3306 R Street Addition

Concept Design Submission

February 4, 2021

South Elevation - Preferred Proposal
1/8" = 1'-0"

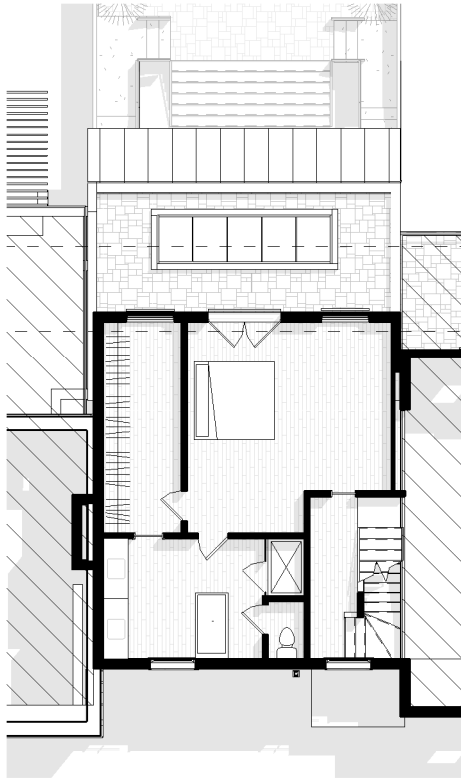
Summary of Discussion of December 3 Meeting

- ☑ Eliminated one dormer in order for a more harmonious roof line
- ☑ Eliminated zinc cladding of second floor elevation
- ☑ Replaced zinc cladding with brick veneer matching existing brick
- ☑ Adjusted fenestration for overall unity
- ☑ Will color coordinate color of structure to be a seamless transition from neighboring properties.
- ☑ The flat facade restores original architectural intent and creates a better flow with neighboring properties.
- ☑ Addressed projection with neighboring properties

South Elevation - Alternative Proposal
1/8" = 1'-0"

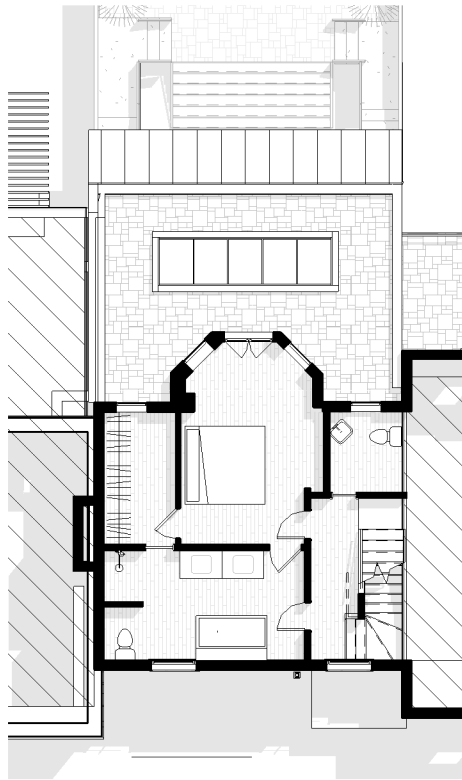
We are sensitive to the cultural heritage of Georgetown, however the rear of the estate at this point has become a mixture of architectural elements not in harmony with the original intent of the architectural design. We are proposing to bring clarity to the rear elevation of the estate articulated in an alternate sober elevation here attached for which we would like to have your input.
